CONSTRUCTION PLANS

/---- ==== COPPER CHASE AT STERLING RANCH

Street & Storm CD's_v2.pdf Markup Summary

CDOT CURB INLET TYPE R DETAIL STD. NO. M-604-12 SHEET 1

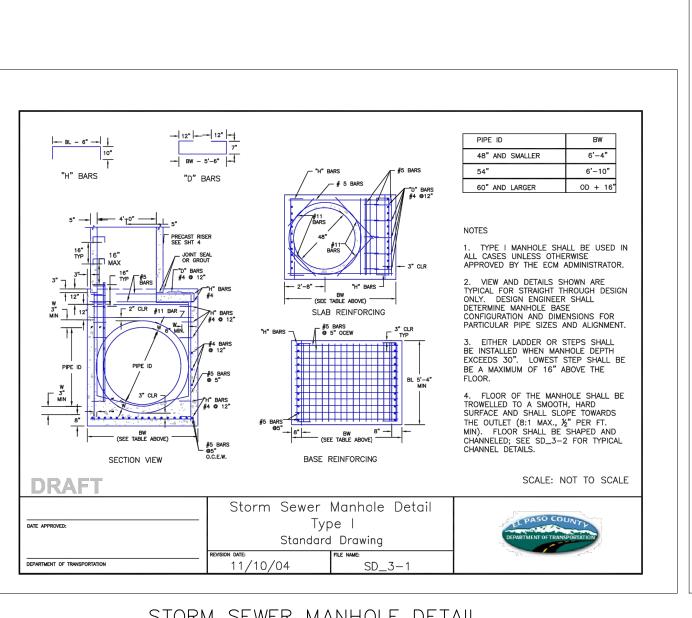
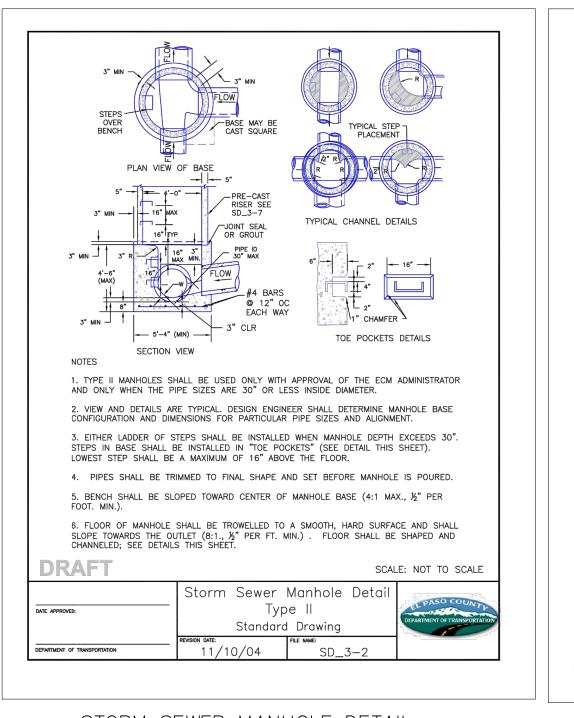
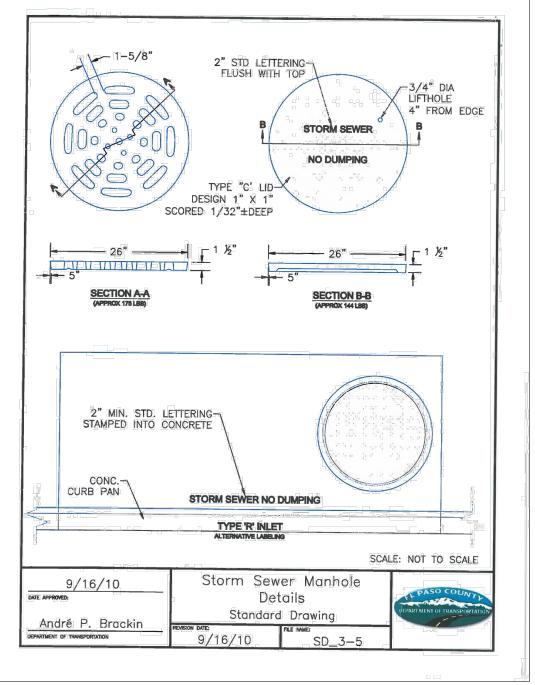
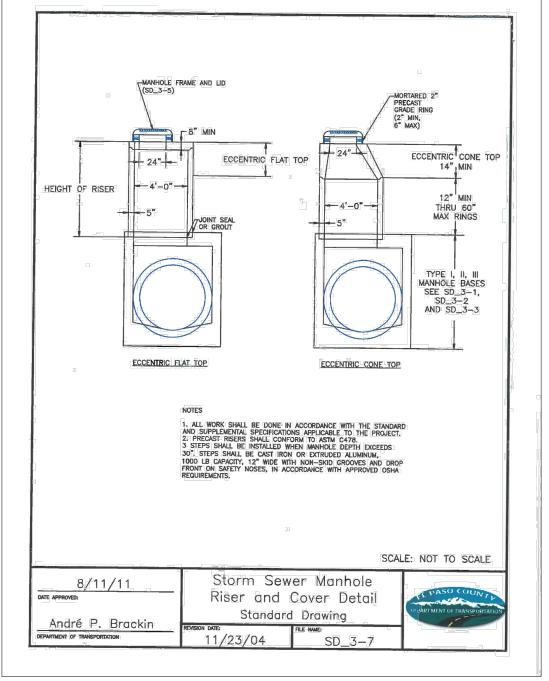
Include detail for beehive inlet THERE IS NO BEEHIVE INLET, THIS WAS MISLABELED AND HAS BEEN REMOVED FROM THE STORM CONSTRUCTION DRAWINGS
